Amendment 3

Solicitation Number 25-01

Temporary School Facilities for Colegio Ponceño

AS-101
SHEET NO.

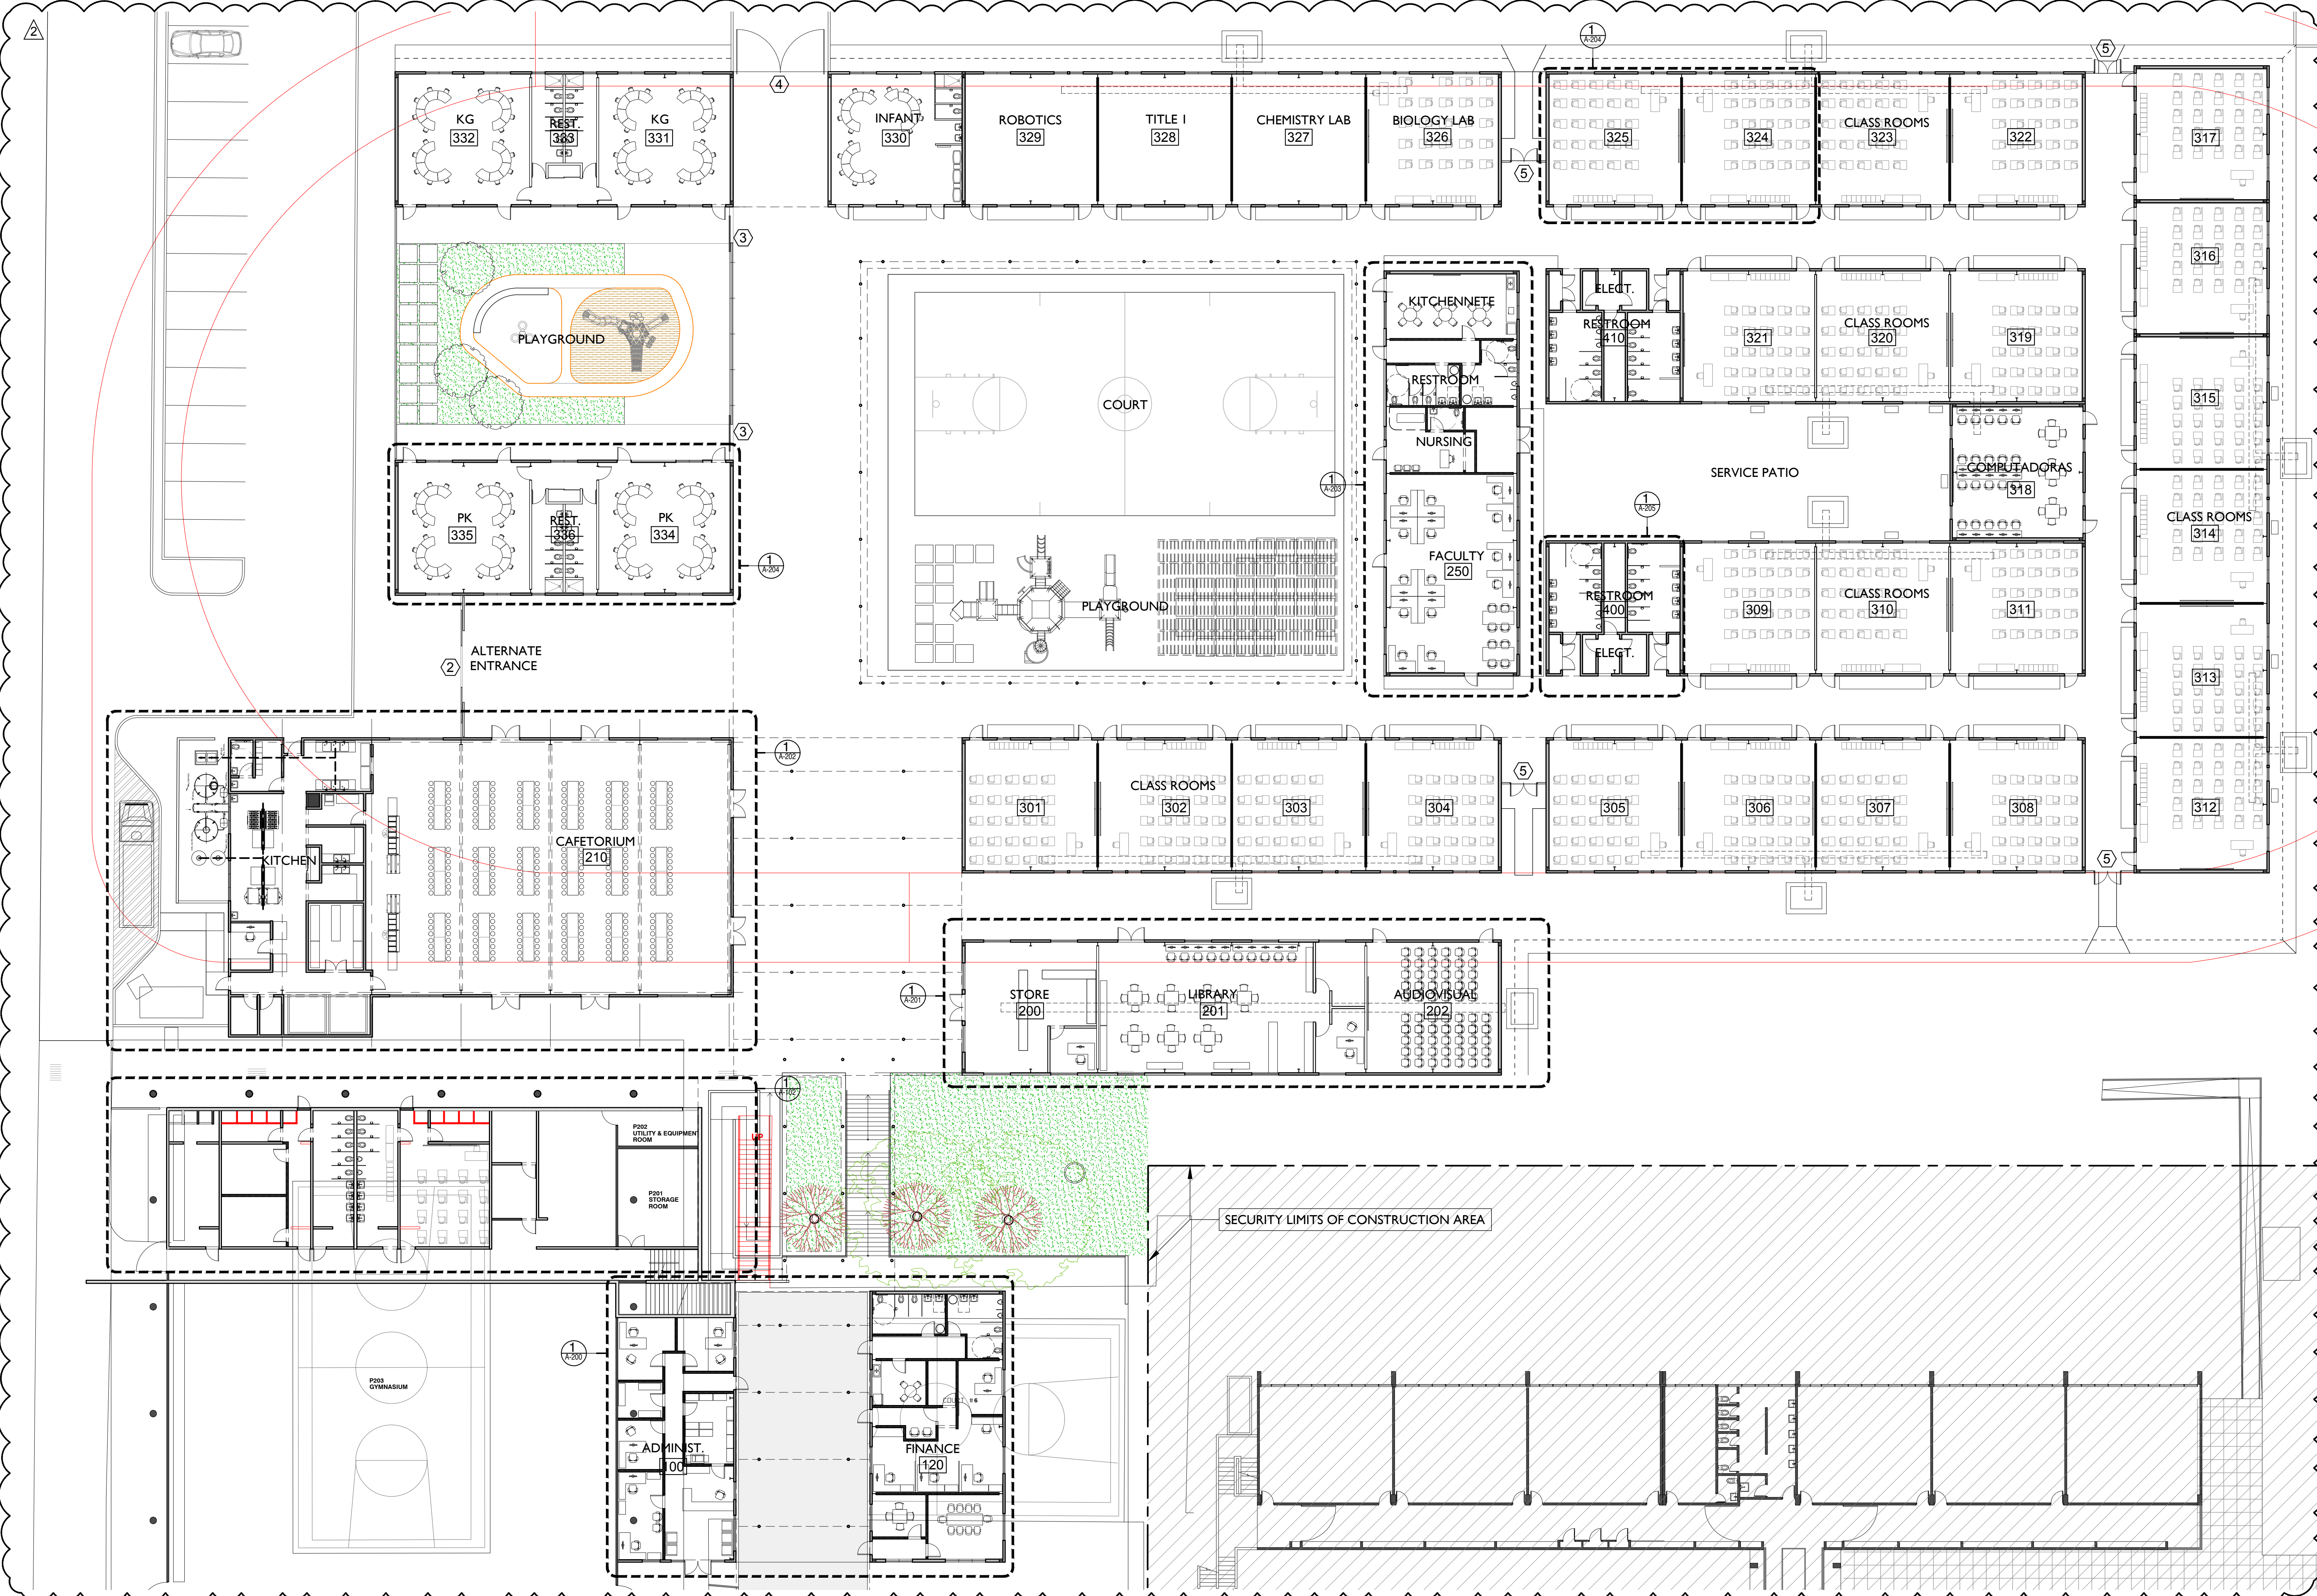
15. Question 19R: There was a misinterpretation of this question. We need construction details for the trash station located at the northwest corner of the project (marked as No. 23 on sheet AS-100). Should we include any gate? Should we include the metal dumpster?

Answer: Consider a typical trash station for one dumpster with a capacity of 4 yards. Concrete floor 9' wide, x 8' deep, walls 6' height, and cyclone fence gate 6' height.

AS-102

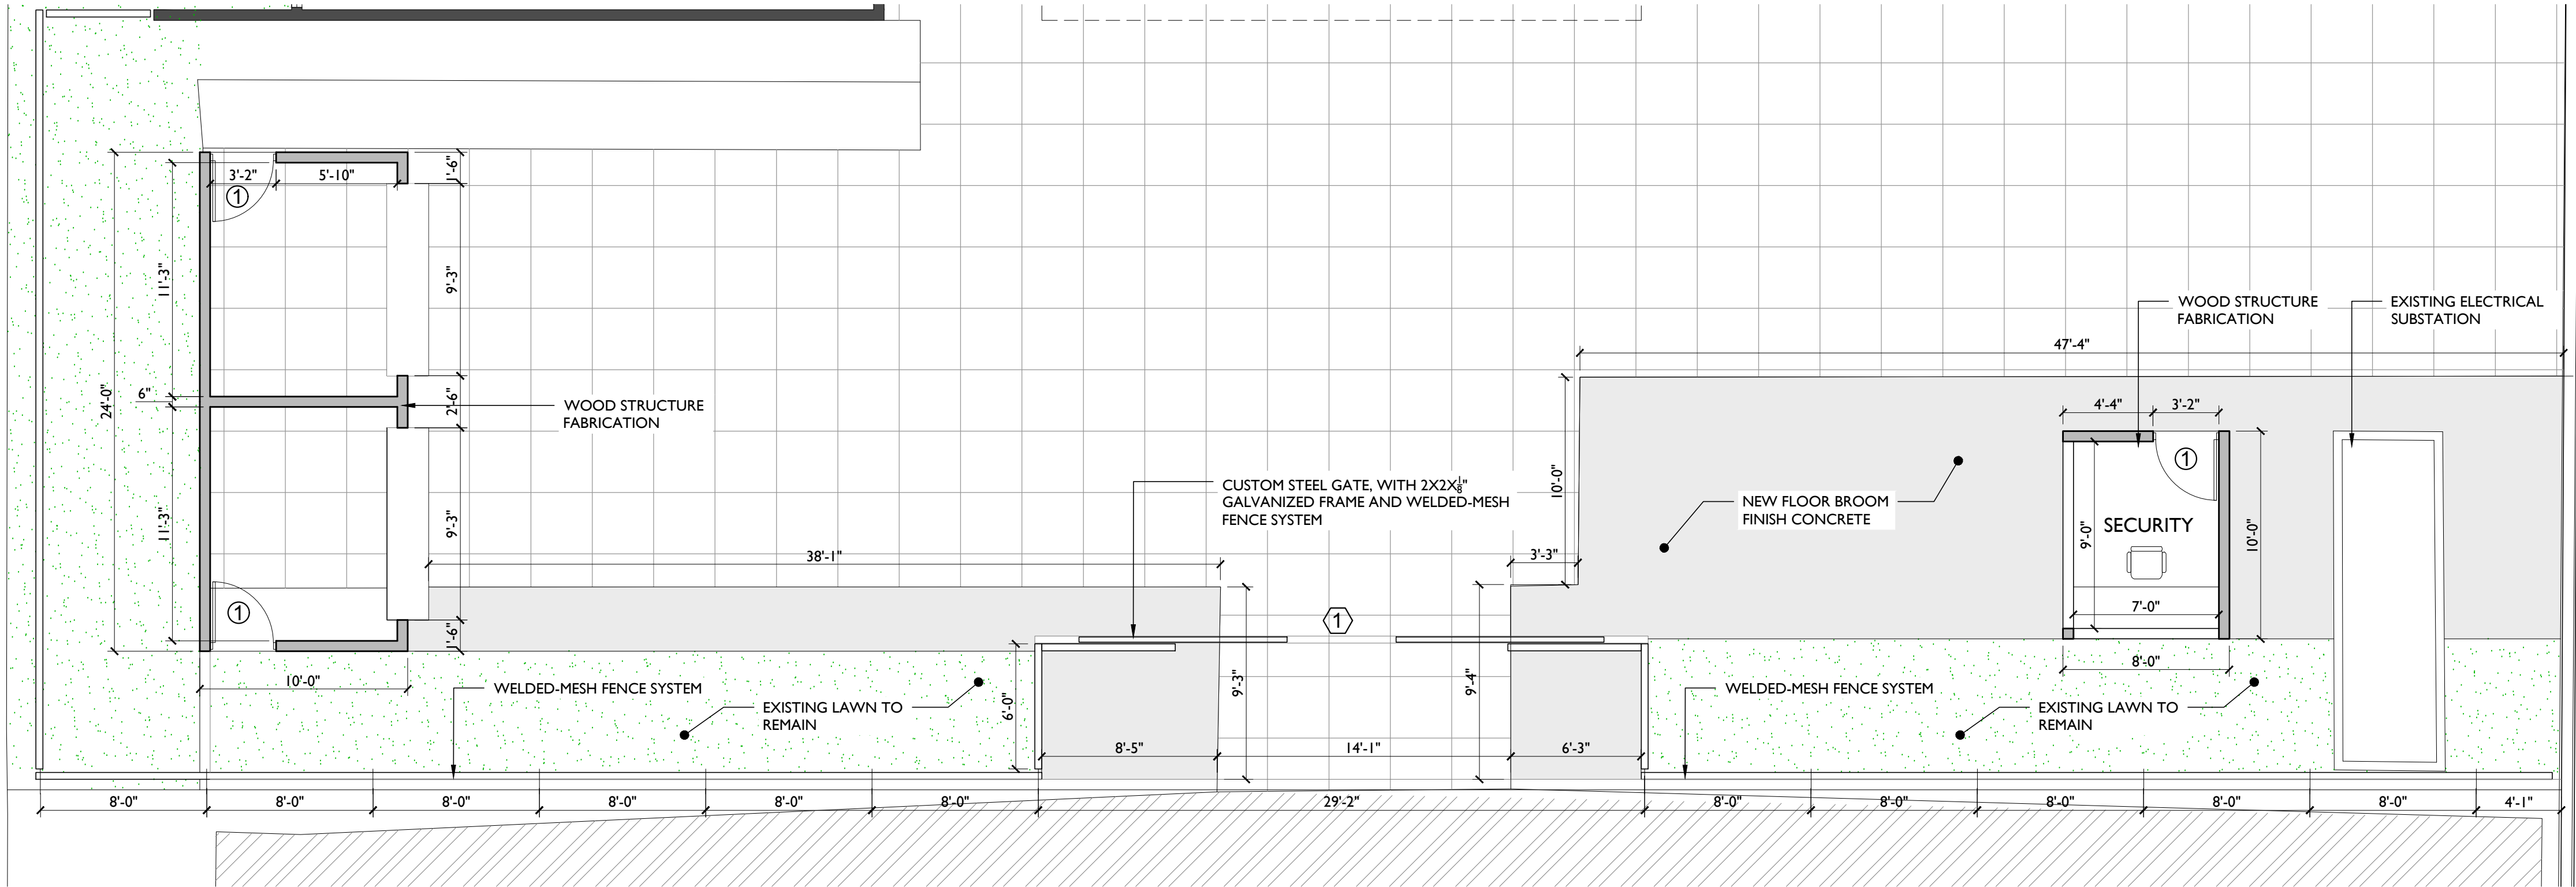
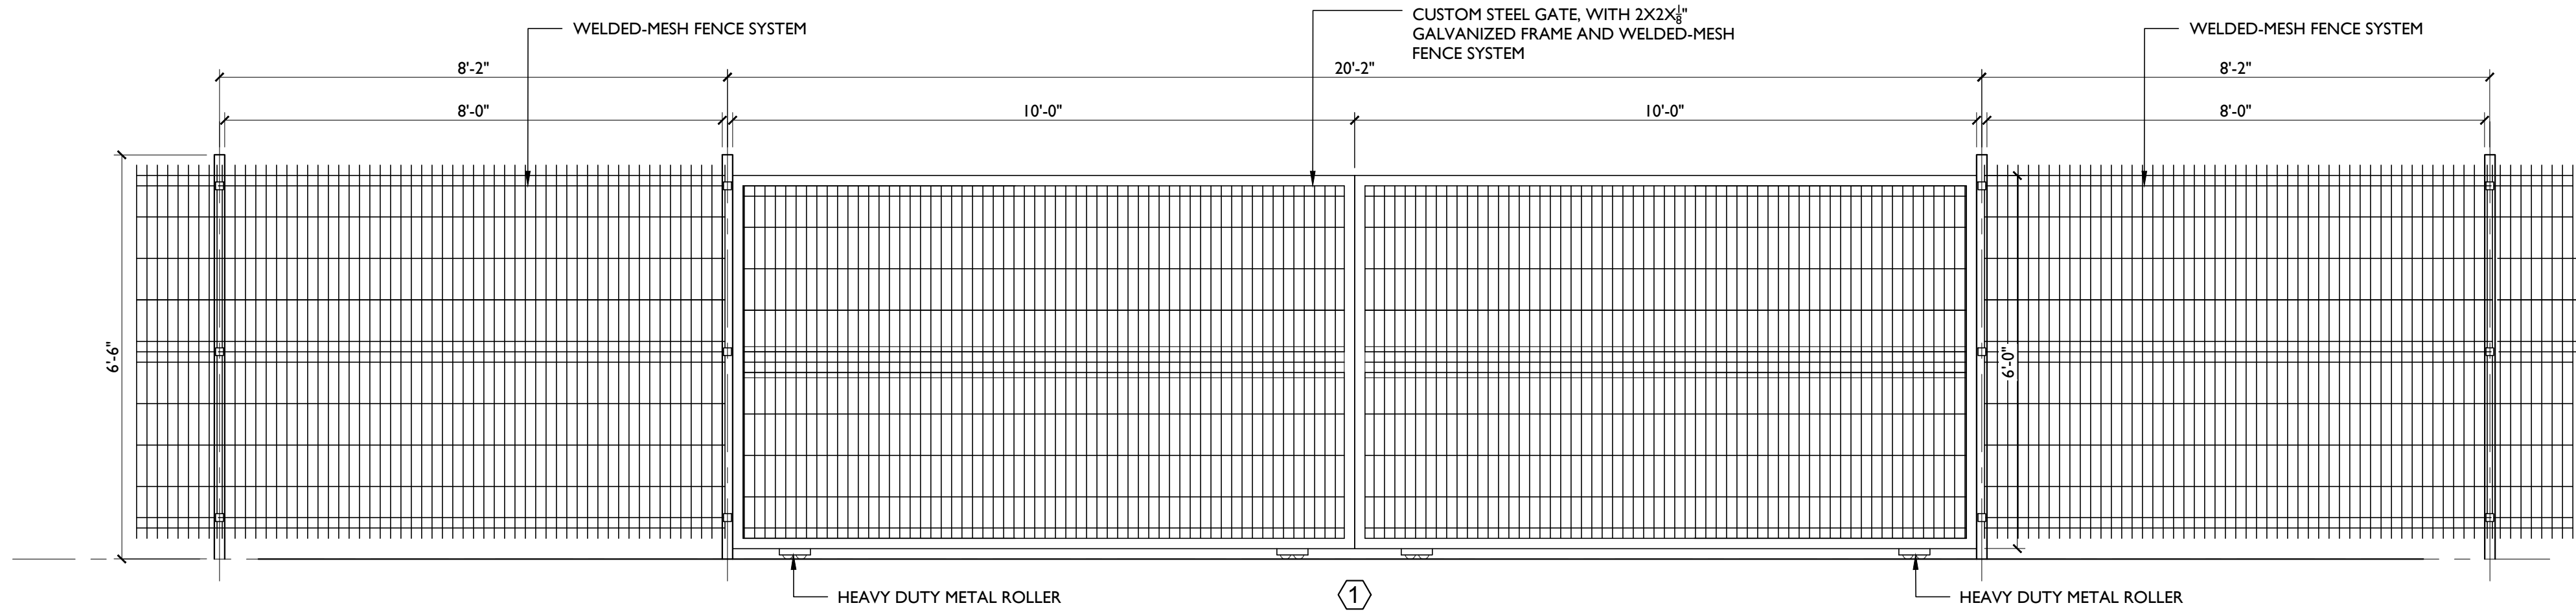
9. 19A: Please provide details for the 6-foot-high temporary chain-link fence (mesh gauge; diameter, thickness, and spacing of vertical pipes; diameter, thickness, and quantity of horizontal pipes; diagonal reinforcements, gates, etc.).

10. Question 19B: Please provide details for the light fence at the temporary school entrance. Does this same detail apply to the Alternate Entrance?

Answer: See attached drawings

Answer: See attached drawings
